Application Note AN-1113

IRS2301 and IR2301 Comparison

Figure 6A. Turn-On Rise Time vs.Temperature

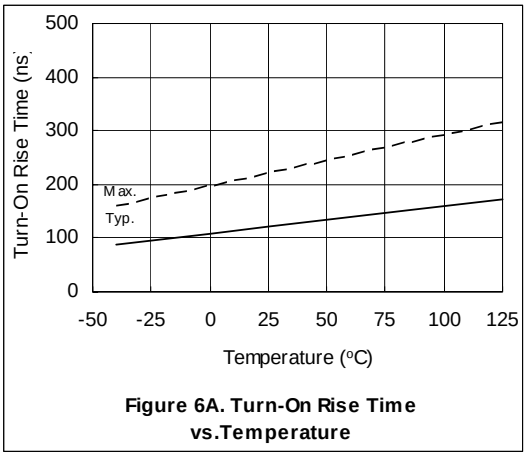
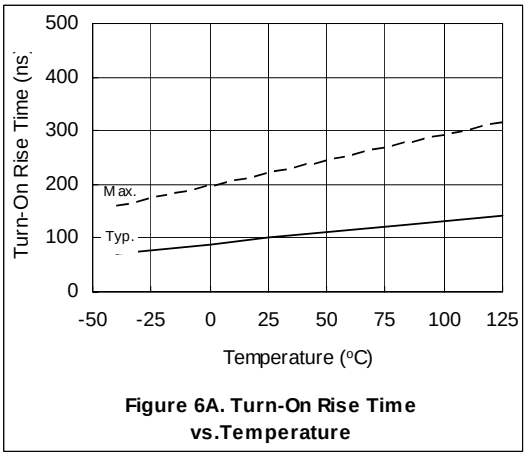
The IRS2301 has faster rise and fall times when compared to the IR2301.

Figure 8A. Logic "1" Input Voltage vs. Temperature

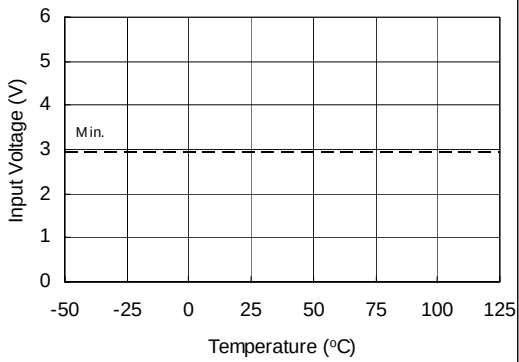
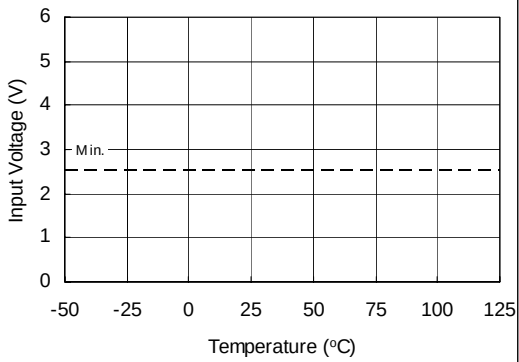
1. The V_{IH} has been reduced to 2.5 V for better 3.3 V logic compatibility.
2. The V_{OH} and V_{OL} are tested using a new standardized test condition of I_O=2 mA. The output driver's on resistance is slightly lower for IRS2301.
3. The typical values for I_{O+} and I_{O-} are higher, which allows faster switching.
